TO: Architectural Review Committee  
Agenda Date: February 6, 2020

SUBJECT: **DESIGN REVIEW #2020-001, Jeff and Meredith Chew.** The applicants are proposing a 1,800-square-foot accessory building that deviates from the siding requirements of Lassen County Code § 18.108.235. Deviation from these requirements is allowed upon approval by the Architectural Review Committee through the Design Review process. The project site is zoned A-2-B-10 (Agricultural Residential 10-Acre Building Site Combining District) and its land use designation is “Rural Residential” in the *Lassen County General Plan, 2000*, as amended by the *Janesville Planning Area, 1993*. The project site is located approximately 13 miles southeast of Susanville and 0.25 miles west of U.S. Highway 395 at 713-560 Oak Tree Lane, Janesville, CA 96114. APN: 129-630-11. Staff Contact: Nancy McAllister, Associate Planner

# Design Review #2020-001, Chew

**ELEVATION VIEWS**

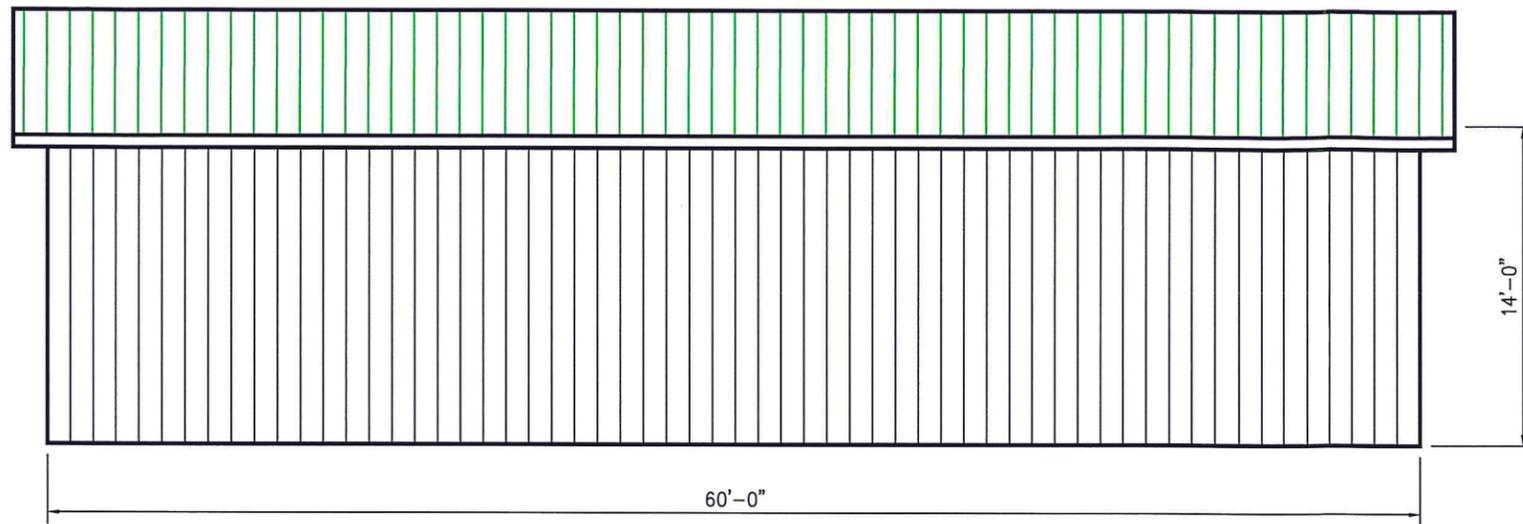
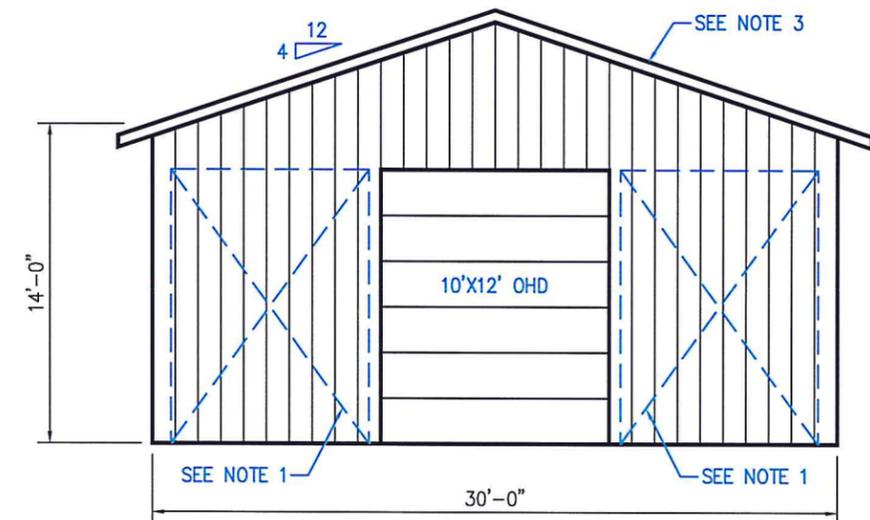
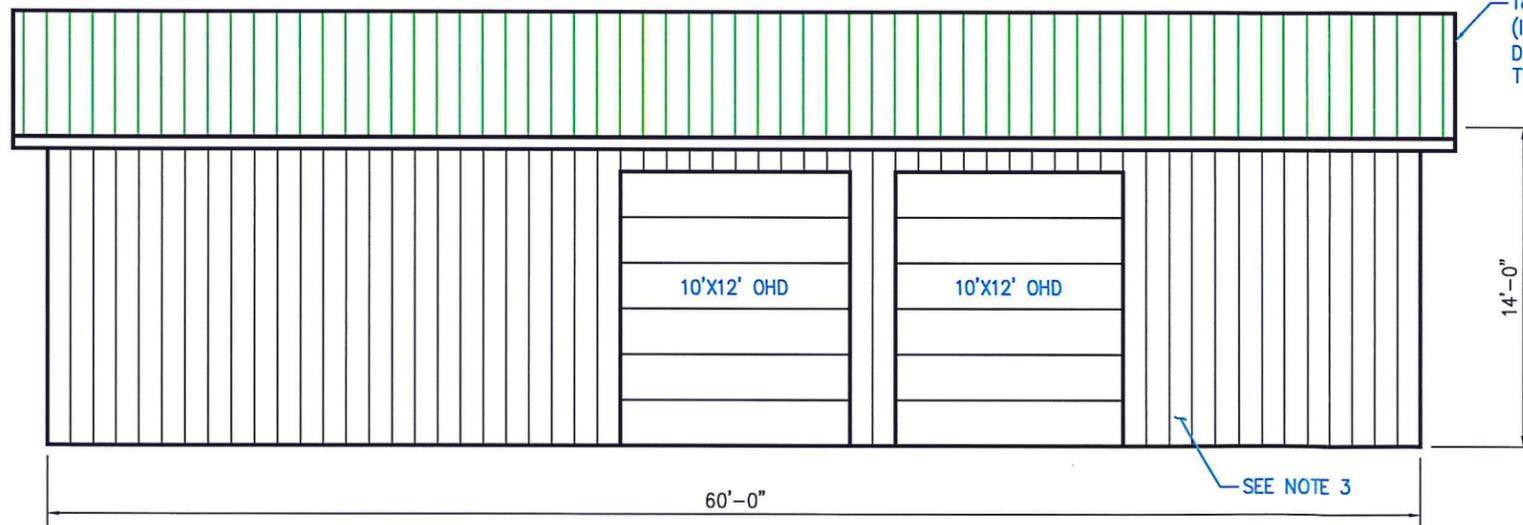
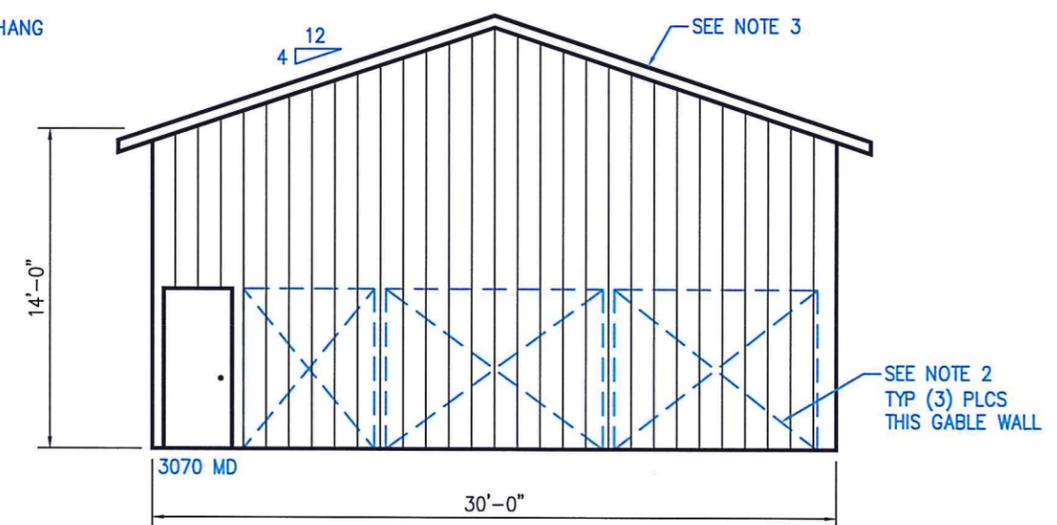
3. The applicants are proposing 1,800-square-foot accessory building (“home shop/garage”) that deviates from the siding requirements of Lassen County Code § 18.108.235. Said section requires that metal and vinyl siding materials be used in conjunction with wood composite siding, natural wood, stucco, masonry, concrete, or natural colored stone.

4. The applicant is proposing 100% metal siding in colors matching the existing residence.
5. The applicant is proposing a 4/12 roof pitch and 18” eave overhangs and gabled ends.

1. The applicant will secure a building permit from the Department of Planning and Building Services before construction of the proposed accessory building.
2. The metal siding of the proposed accessory building must be treated with an oxidation inhibitor and shall have a no-glare surface.
3. The proposed accessory building shall not be painted in florescent, luminescent, or other extreme colors, which detract from the appearance of the neighboring property, the community as a whole or the natural environment.
